RE: **Percolation Certification Plan Revision 7644 Green Dell Lane PC528471**
The following adjustments or edits are needed on the submitted Percolation Certification Plan for the subject property.

PERCOLATION CERTIFICATION PLAN

LIME KILN VALLEY
LOT 17
7644 GREEN DELL LANE

RE: Walk-through Building Permit Application for In-ground Pool

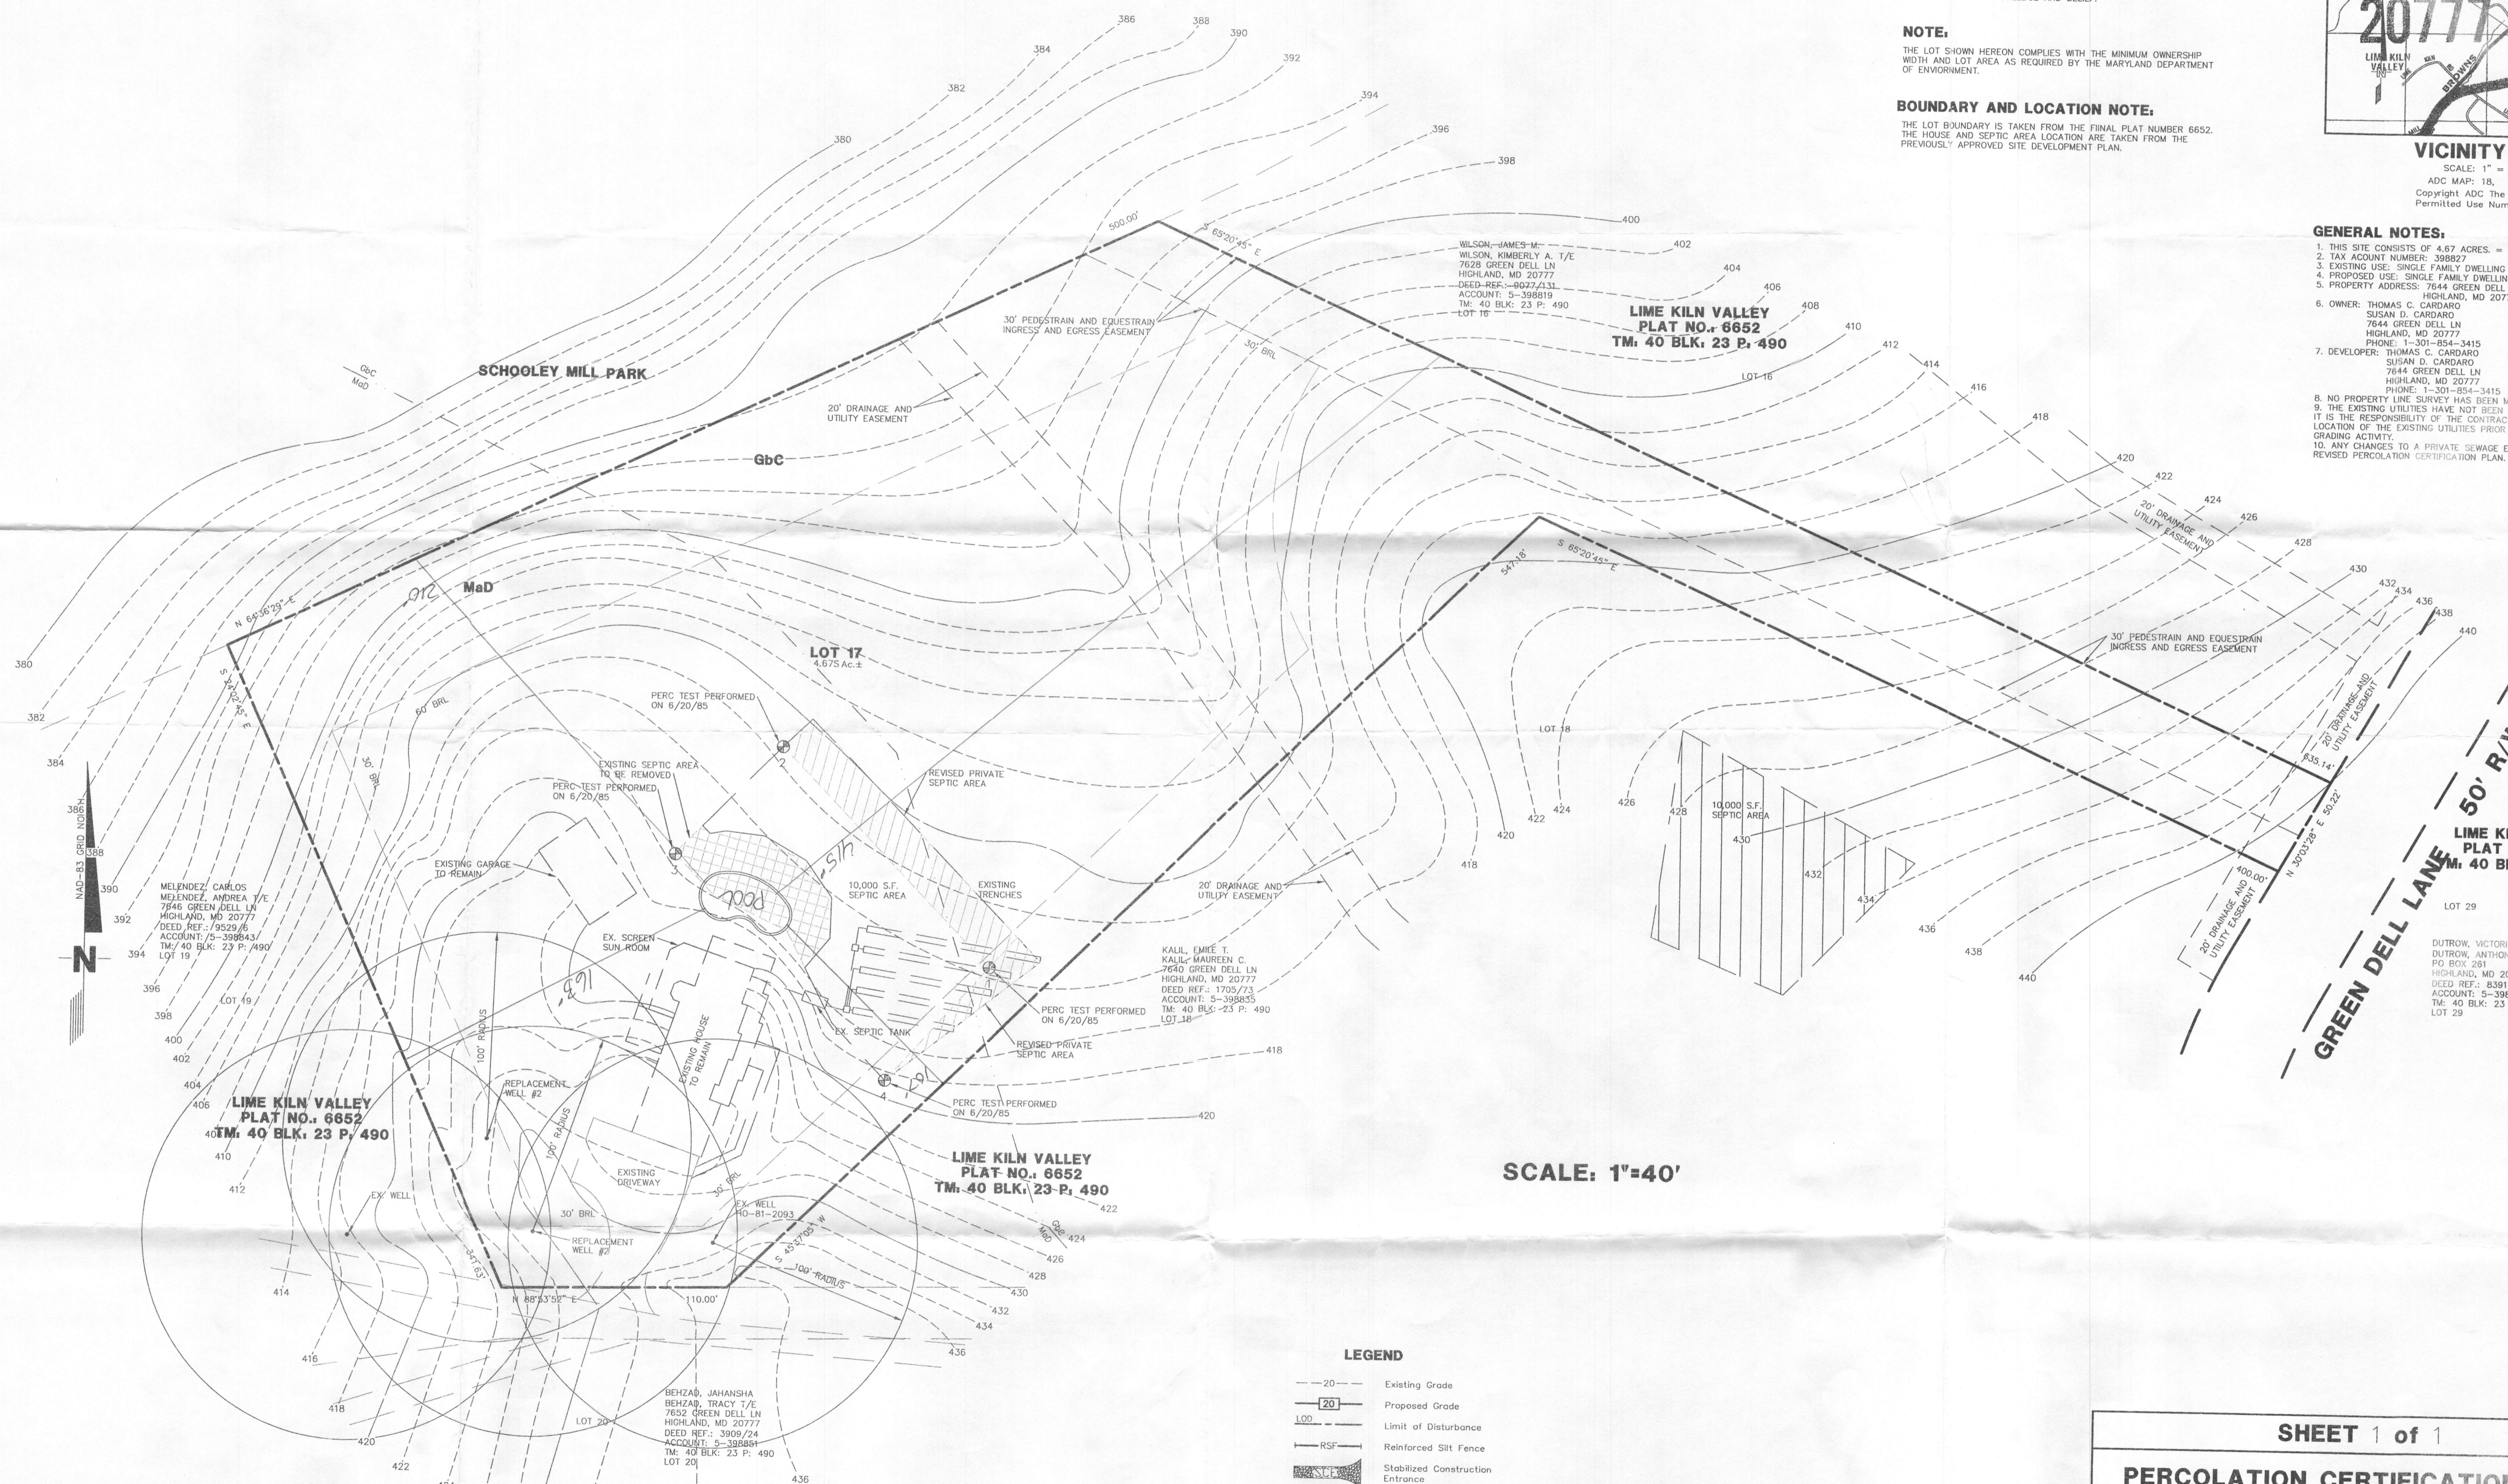
- 1) Correct date on perc tests to 6/20/85 ✓
- 2) Extend revised easement to include existing trenches. ✓
- 3) Show 2 alternative (re: replacement) well locations with 100-foot elliptical radius for each. The sites should be 50 feet apart. Setbacks are as follows: 10 feet to property line, 30 feet to structure such as house or garage, 20 feet to pool (waterline), 100 feet to septic tank or septic easement or 200 feet to septic tank or septic easement that is more or less directly uphill of the well site. ✓

- 4) A note is needed concerning well locations. For example, ALL EXISTING WELLS ON THE SUBJECT PROPERTY AND WITHIN 100 FEET OF SUBJECT PROPERTY BOUNDARIES ARE REPRESENTED TO THE BEST OF MY KNOWLEDGE AND BELIEF. ✓

- 5) This note is required: THE LOT SHOWN HEREON COMPLIES WITH THE MINIMUM OWNERSHIP WIDTH AND LOT AREA AS REQUIRED BY THE MARYLAND DEPARTMENT OF ENVIRONMENT. ✓

- 6) Use notes to identify sources (i.e. plats) you used as references, or cite those references within the notes. For example the lot boundary is from the final plat or perhaps the location drawing which would also include the house footprint. The topography would be from the original approved perc cert or maybe the approved site plan. ✓

- 7) A Percolation Certification Plan must include the soil map units. I am sending a print output (1 inch:100 feet) from Howard County GIS that shows the USDA-NRCS 2003 soil map units. I have entered the proper labels. ✓

- 8) The certification statement must be signed and dated by the preparer. For a surveyor or engineer preparing the plan: "I CERTIFY THAT THE INFORMATION SHOWN HERON IS BASED ON FIELD WORK PERFORMED BY ME OR UNDER MY DIRECT SUPERVISION, AND IS CORRECT, TO THE BEST OF MY KNOWLEDGE AND BELIEF." Alternatively the professional's seal may be affixed and signed. ✓
